Evaluation of a proposal for reliable low-cost grid power with 100% wind, water, and solar

Supporting Information for the paper “Evaluation of a proposal for reliable low-cost grid power with 100% wind, water, and solar”

Fig. S1. Panel B of Figure 4 of ref. [11]

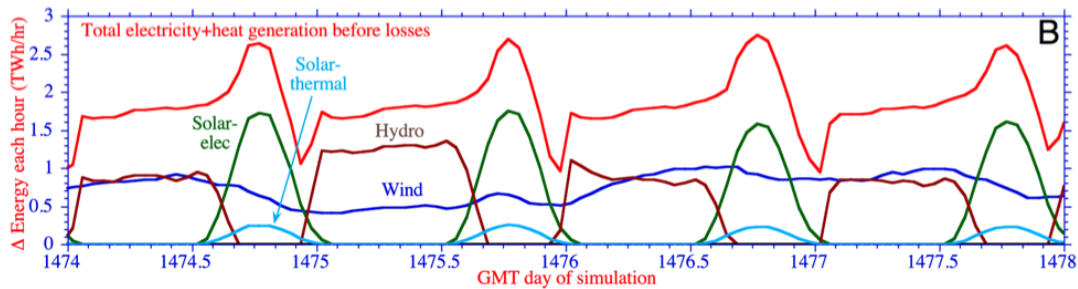
S1.1: Hydroelectric Capacity. The analysis in ref. [11] relies on much more hydroelectric capacity than can reasonably be expected to be available. In ref. [11], the total installed hydroelectric power capacity in the U.S. system, as defined in Table S2 of its supporting information (SI), is 87.48 GW. In addition to this, Table S1 of its SI defines the maximum discharge rate for new pumped hydroelectric capacity (assuming that all of this is completely new capacity and not existing capacity with added pumping) to be 57.68 GW¹. Thus, assuming that conventional hydroelectric generation and “pumped” hydroelectric power production capacity is separate, the total maximum theoretical output of all hydroelectric capacity postulated in ref. [11] is 145.16 GW.

Figure S1 (which corresponds to Panel B of Figure 4 in ref. [11]), shows the power supplied by different sources in TWh/hr, which is effectively the average power for each hour in the unit of TW, for a period of four days in January of 2055. Readers of ref. [11] are given only a few snapshots of the modeling results, but as an example, for half of the simulated day of 15th of January 2055, hydropower is depicted as supplying ~84% of total system load, averaging 1.3 TW (1,300 GW) over a period of 13 hours, or approximately 9 times the theoretical maximum instantaneous output of all installed conventional hydropower and pumped storage combined. It is not feasible for an installed hydropower capacity of 87.48 to 145.16 GW (depending on whether pumped hydro is included in these figures in the hydro output or in non-underground thermal energy storage output) to produce 1,300 GW for hours at a time. It is worth noting that 1,300 GW is more than the current combined generating capacity of all the U.S. power plants. Furthermore, this error is not limited to a single figure in ref. [11]. The hydroelectric production profiles depicted throughout the dispatch figures reported in both the paper and its supplemental information routinely show hydroelectric output far exceeding the maximum installed capacity as well. Both Figures S4 and S5 of its SI, for example, depict hydroelectric generation rates exceeding 700 GW. This error is so substantial that we hope there is another explanation for the large amounts of hydropower output depicted in these figures. In [12] the authors state that “We constrain hydropower to existing capacity in each state except in the case of Alaska.” Then in [11] the authors state values from [12] are used.

Fig. S3. Lowermost panel of Figure S6 of ref. [11]

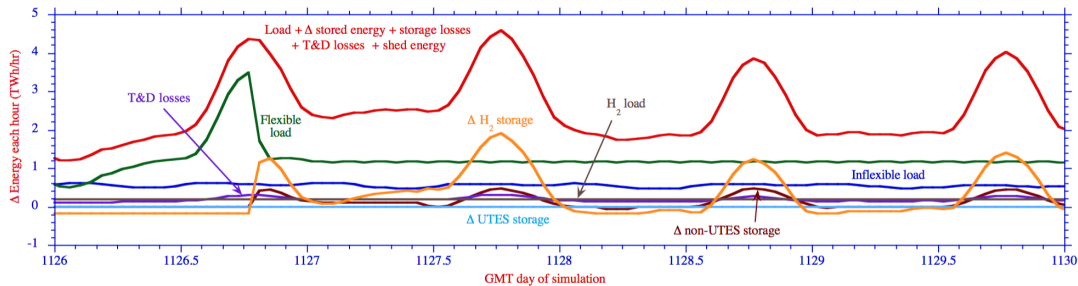
In addition, it appears from the modeling results shown in ref. [11] that no physical limitations have been placed on the rate of hydrogen production in the system. In Figure S6 of its SI, it is shown that a hydrogen charge rate (power going to hydrogen production) of almost 2 TW is achieved, nearly double the total current installed generating capacity of the United States. The actual capacity for hydrogen production is never explicitly presented in ref. [11] and is not appropriately accounted for in the cost estimates⁶. The authors of ref. [11] provide no information regarding the hydrogen production equipment (electrolysis, etc.) that would enable a hydrogen production rate of at least 2 TW, as shown in the dispatch figures (see the lowermost panel of their Figure S6; shown here below in Figure S3).
